AMENDMENTS TO THE DRAWINGS

This document is a response to the Office Action mailed October 24, 2008.

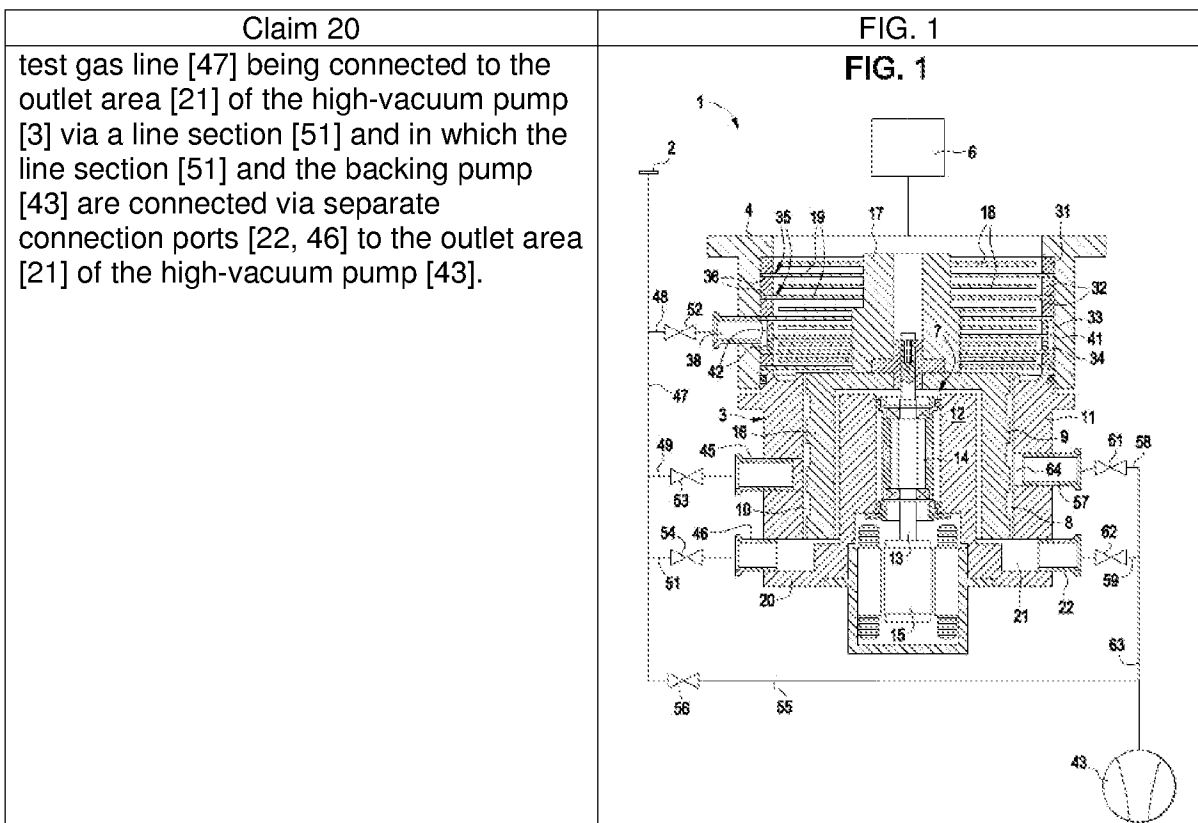
The drawings stand objected to under 37 CFR 1.84(l) because the reference characters and some lines in the context of the drawings, particularly in Figs. 2 and 3, are not uniformly thick and well-defined. The drawings also stand objected to under 37 CFR 1.83(a) because they fail to show the separating means of claim 37.

In response to the Examiner's comments regarding lines and characters not uniformly thick or well-defined, replacement sheets for corrected Figs. 1, 2 and 3 are provided. The lines and characters have been made uniform and more well-defined. Furthermore, corrections have been made with respect to reference numerals 9, 10, and 16 in accordance with the use of the reference numerals in the detailed description.

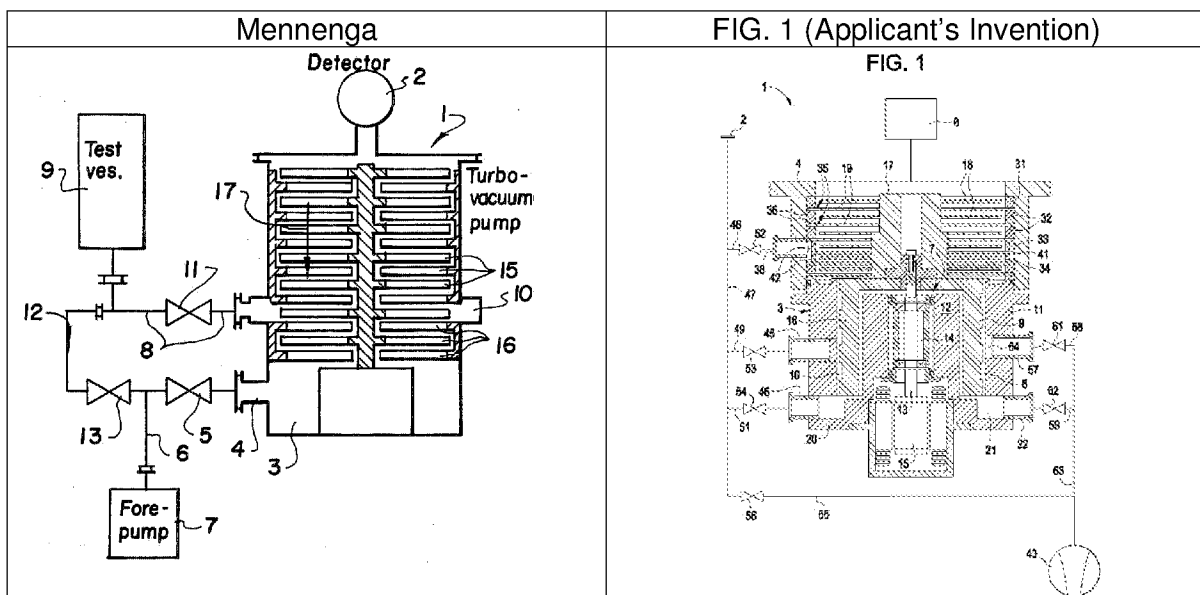
Claims 20, 25, and 26 stand rejected under 35 U.S.C. 102(b) as being unpatentable over U.S. Patent 4,472,962 to Mennenga ("Mennenga"). Claims 21-24 and 27-28 stand rejected under 35 U.S.C. 103(a) as being unpatentable over Mennenga. Claims 29-39 stand rejected under 35 U.S.C. 103(a) as being unpatentable over U.S. Patent 5,561,240 to Ochiai ("Ochiai"), in view of Mennenga.

As shown in the side-by-side comparison of revised FIG. 1 of the Applicant's invention and the figure from Mennenga, while the outlet area [21] of the high-vacuum pump [3] of the Applicant's invention has separate connection ports [22, 46], Mennenga teaches an outlet area [3] of the high-vacuum pump [1] with only a single connection port [4] (i.e., Mennenga does not disclose an outlet area with separate connection ports).

As is clearly evident from the figure from Mennenga above, Examiner's reliance on element [10] of Mennenga as being a separate connection port to the outlet area [3] (OA at p. 3) is misplaced for a variety of reasons. First, element [10] is described by Mennenga and shown in the figure as an "annular channel" (Mennenga at 3:13-15) and not a connection port. And even if element [10] were a connection port, which it is not, it is not connected to the outlet area [3], but instead is connected to the inlet area. Accordingly, in Mennenga, all test gas enters the vacuum pump through the unlabeled inlet connection port (connected to line [8]) and must then pass through the pump area, and not directly through the outlet area [3] below the pump area. As such, Mennenga neither discloses the mechanical setup of the Applicant's invention, nor reduces the response time in the manner of the Applicant's invention. And since Mennenga does not disclose an outlet area with separate connection ports, Mennenga obviously also fails to disclose the Applicant's invention's second connection port [46] connected to the test gas line [47] via line section [51] to increase the response time of leak detection.
